## MEMORANDUM

**SUBJECT:** **Public Hearing Report** for ZC #11-03F, Wharf Pier 4  
Modification and Second Stage Planned Unit Development

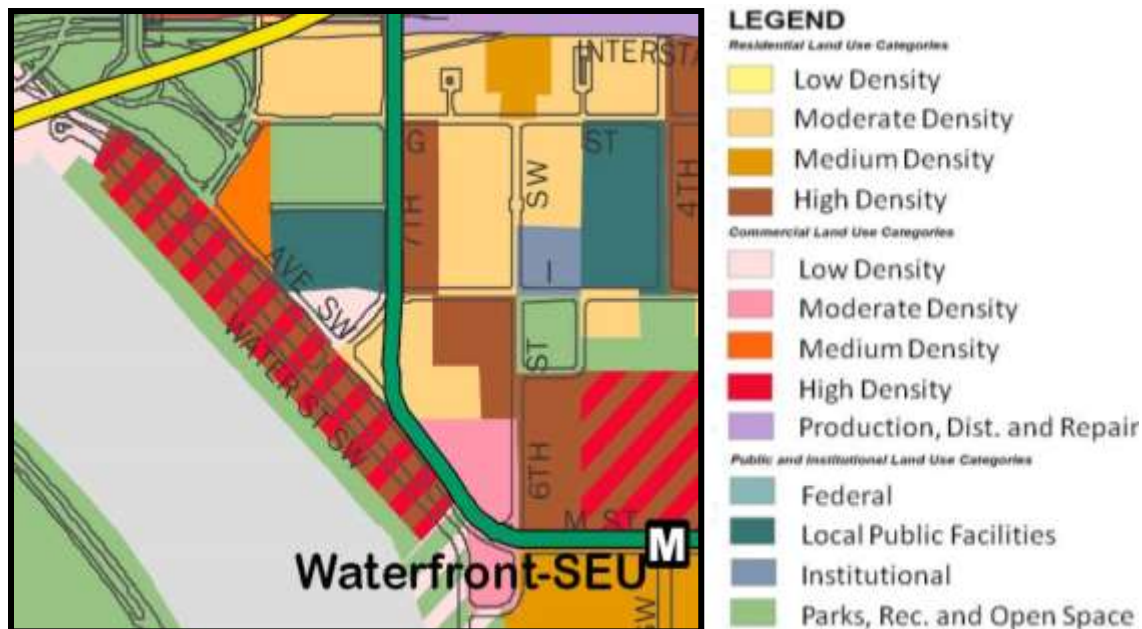
Since the time of setdown, the design of the building has been revised. Major changes include curved building “corners”, significant additional windows, and a reduced size of the third floor. Revised material selections include wood panels and soffits, architectural polished concrete block at the pier level, and metal panels on much of the side of the building as well as the primary building entrance. OP strongly supports the design of the building. Exhibit 23, the revised plan set, provides information on the lighting proposed for the pier (see Sheets 1.20 and 1.21). As of this writing, the submitted materials do not include information on the materials of the pier itself, but in email correspondence with OP, the applicant has indicated that the existing concrete surface on the existing pier would remain, and that the new finger pier would also have a concrete surface. OP notes that construction is already underway on the finger pier.
